Washington State Convention Center Addition Project

Design Review Board Design Recommendation Meeting 03
01-16-2018

PROPERTY ADDRESS	SITE A 1600 9th Avenue
SDCI PROJECT #	3020176

This Design Recommendation Meeting #3 is to cover response to the recommended conditions and updates to departures, including 3 new departures based on further MUP review. Additional information has been provided for reference.

ENLARGED SOUTH ELEVATION - PINE STREET

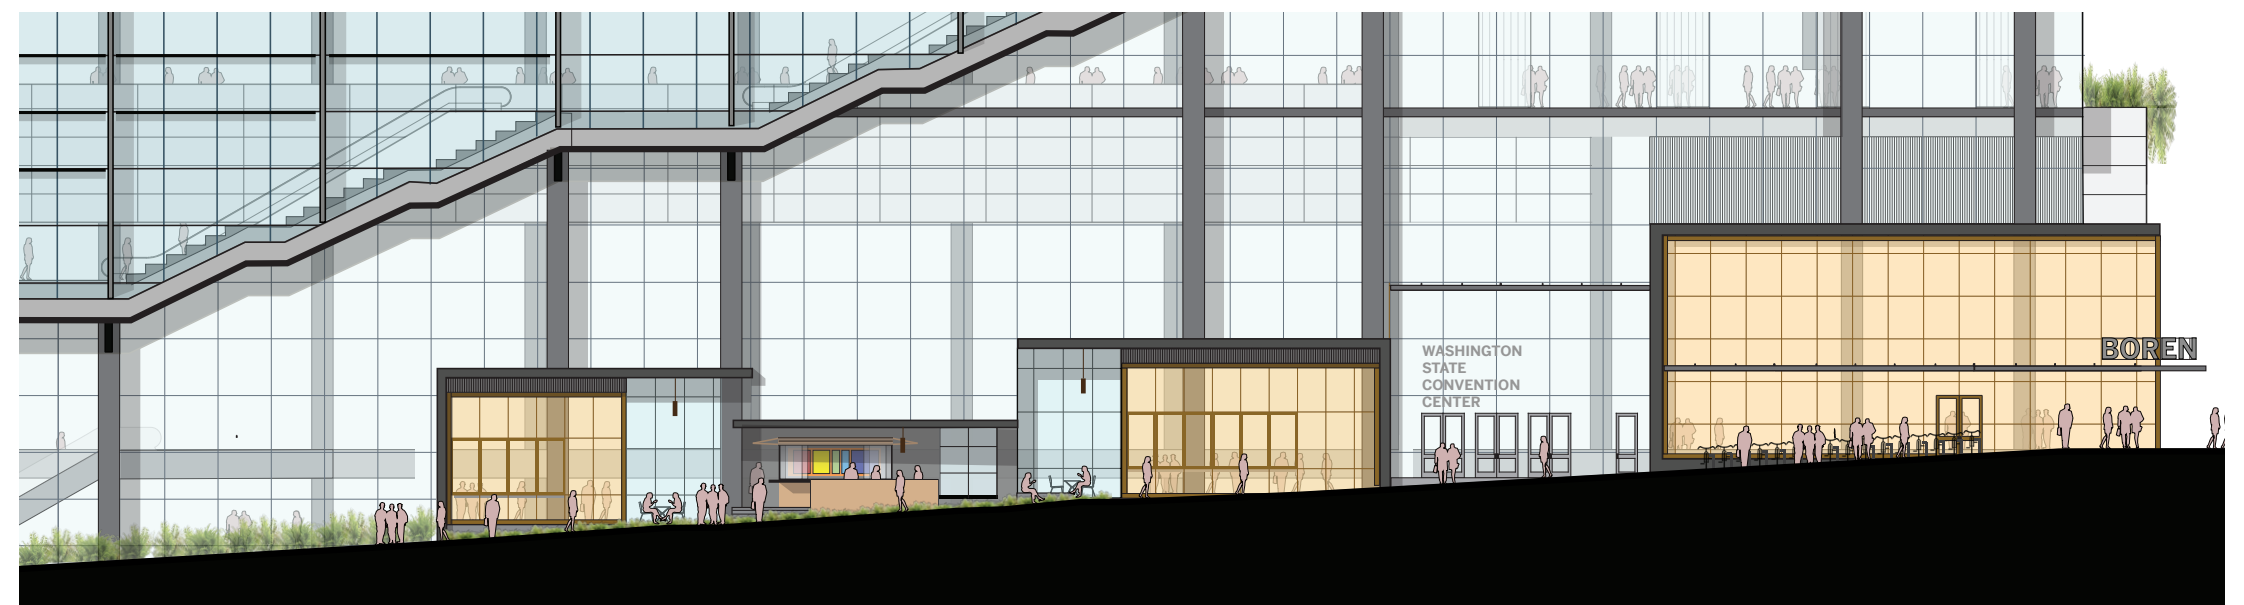
The soffit under the stair is highly visible and requires quality materials, tight joints and excellent detailing, to ensure metal flatness and a slender stair riser profile. If the soffit is reflective [20], provide a thorough exploration of matte and satin finishes that are less than mirrored, and may perform/maintain better in the northwest winter climate.

RESPONSE CONDITION #2: The graphic strategy for these retail panels is to bring interest to the pedestrian experience with the visual language of Capitol Hill.

UPDATED DESIGN: bikeshare station removed and additional benches added at sidewalk per SDC guidance

SOUTH ELEVATION - PINE STREET

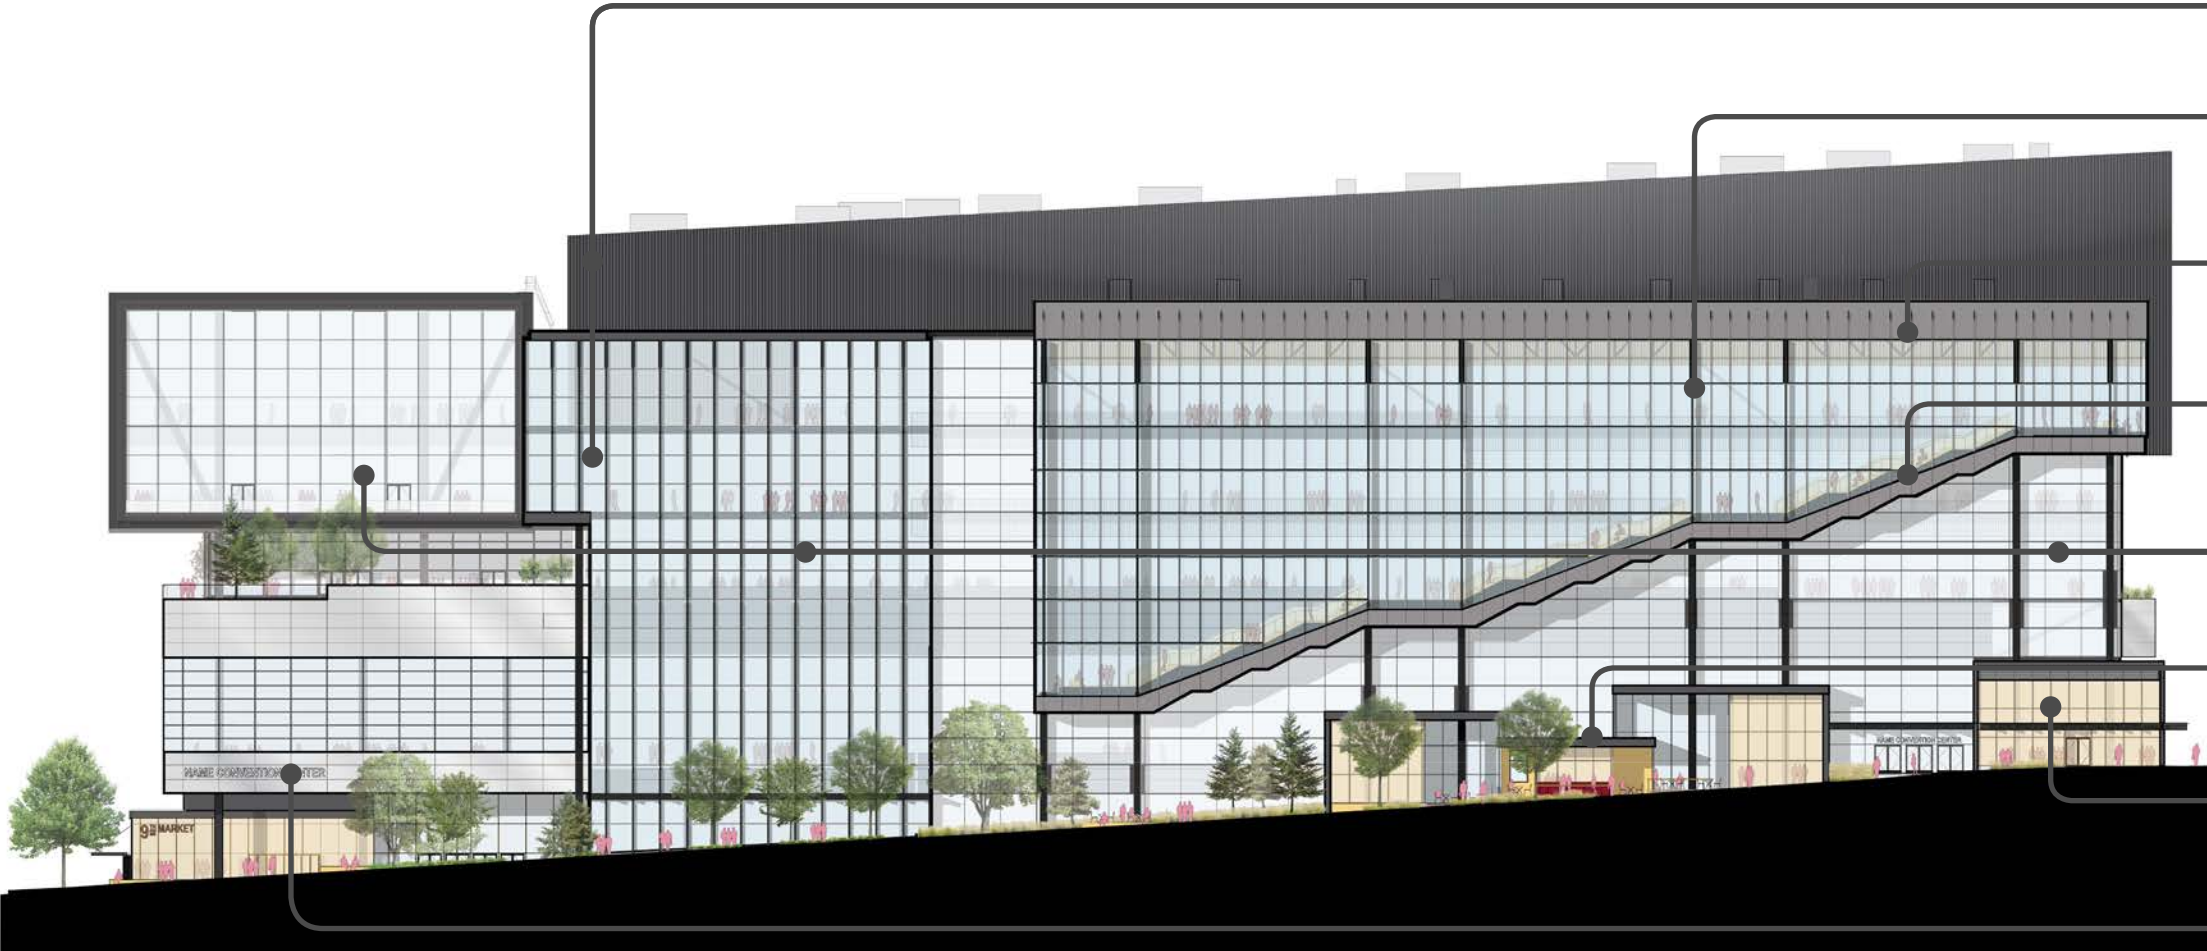
The translucent top bands shown on pg 20, 39 and 87, should not be a uniform opaque appearance as shown, but rather be translucent and show the structural shadows and light-play within, as stated at the meeting. Exploration of channel glass and other quality translucent materials for these two critical skyline defining elements is encouraged.

- UPDATE: massing refined to better frame public plaza and clarify building forms
- UPDATE: reduced quantity of structural fins to allow more clear views from interior to exterior
- RESPONSE CONDITION #3: opaque metal panel at top of hillclimb has been reduced
- RESPONSE CONDITION #1: refined stair and glazing profile to simplify material detailing
- UPDATE: simplified curtain wall structure to provide more transparency
- RESPONSE CONDITION #2: Pine Street retail roofs illustration graphics
- UPDATE: glazing system and soffits refined at retail areas
- UPDATE: landmark lighting removed and signage added to facade to subtly provide clarity and wayfinding

EAST ELEVATION - BOREN AVENUE

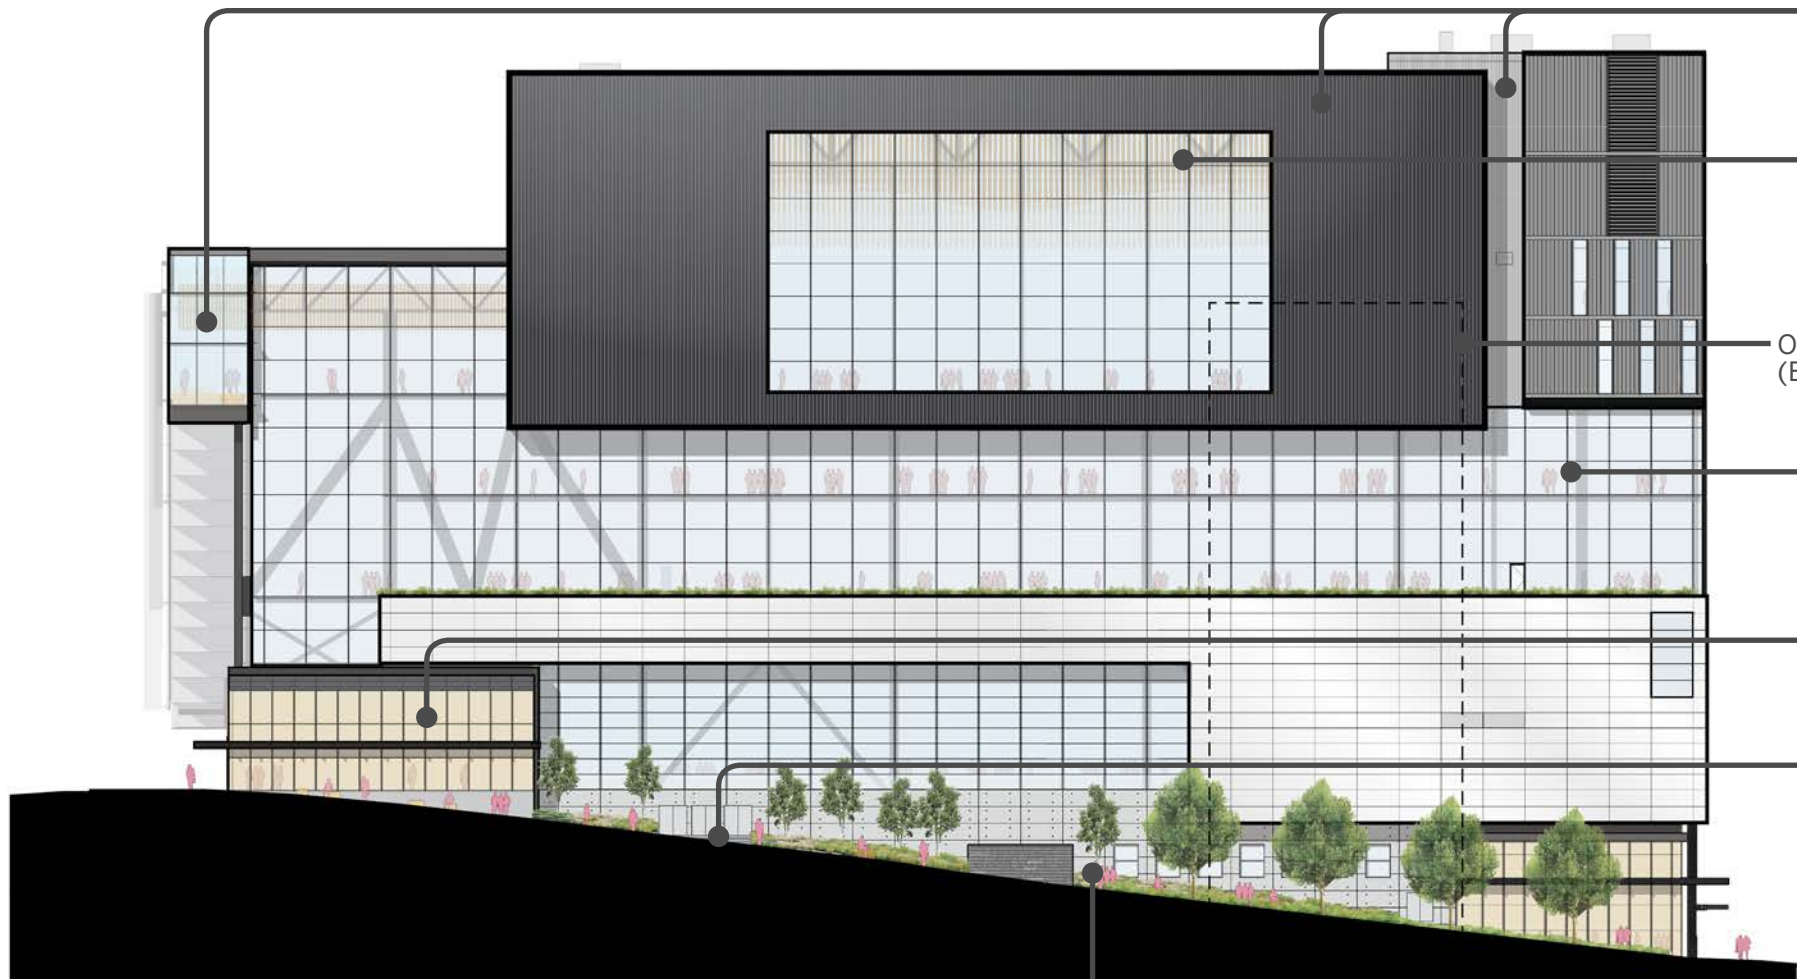
All the ground level concrete along Boren should have a finer grain texture than that shown on pg 32/F; it should be deeply scored more frequently than the 8ft shown on pg 39, and/OR the entire strip of plantings hugging that concrete wall should be 3-5 ft tall (yet not create CPTED issues) (see departure 4b).

UPDATE: refined massing and proportions to better clarify building forms

RESPONSE CONDITION #3 & 4: additional transparent glazing at top of ballroom; lighting fully internalized and integrated with interior ceiling system. Window proportion adjusted to reduce visual impact.

UPDATE: simplified curtain wall structure to provide more transparency

UPDATE: egress stairs shifted to better distribute planting and seating along Boren frontage

RESPONSE CONDITION #5: additional trees and sloped planting to add variety and texture

RESPONSE CONDITION #5: Public Benefit artworks add visual interest and focal points with integrated seating areas; seating design and lighting elements to be incorporated into the garden in coordination with the selected artist, per SDC guidance. This area is also a public benefit.

NORTH ELEVATION - OLIVE WAY

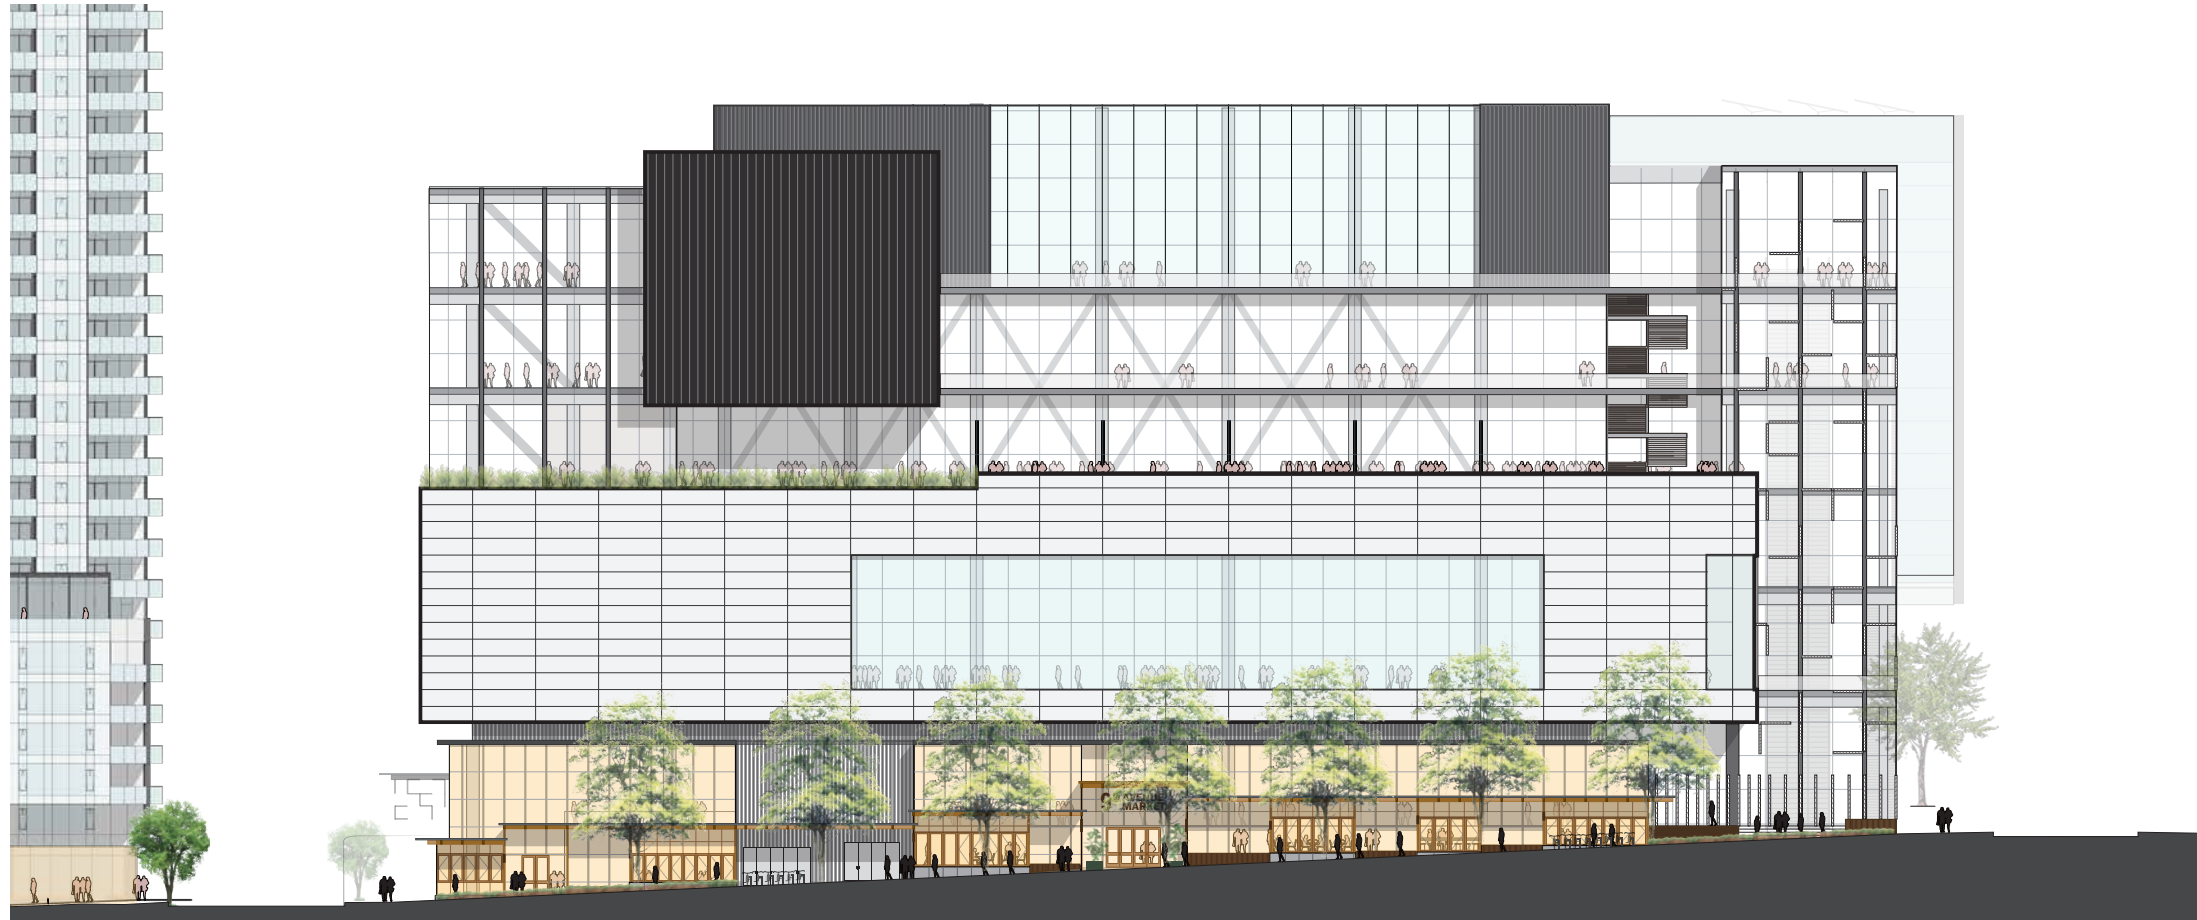
RESPONSE - The design was revised to bring vertical glazing down to grade in multiple locations at exits. Additional Public Benefits artworks to be developed by artist at (5) glass vitrines, per SDC guidance.

- UPDATE: refined massing to better articulate urban block patterns and break down scale
- UPDATE: glazing pattern refined to coordinate with adjacent glazing pattern and massing
- UPDATE: planters articulated with wood paneling; locations revised within frame to better provide views from interior spaces; glazing behind revised to animate facade
- UPDATE: simplified curtain wall structure to provide more transparency
- UPDATE: landmark lighting removed and signage added to facade to subtly provide clarity and wayfinding
- UPDATE: window proportion changed to better define massing and address interior functions
- UPDATE: entry canopy more pronounced

- RESPONSE CONDITION #6: translucent glazing continues to pedestrian grade level at exits; artworks to be developed by artist at (5) glass vitrines, per SDCI guidance
- UPDATE: additional area open to below to provide increased visibility for pedestrians into exhibit space and provide visual interest
- UPDATE: additional planting and seating added along Olive Way frontage with potential bus stop
- UPDATE: vehicle entry shifted east to be off axis with Terry Avenue, per SDOT & SDCI feedback, landscape added at terminus.
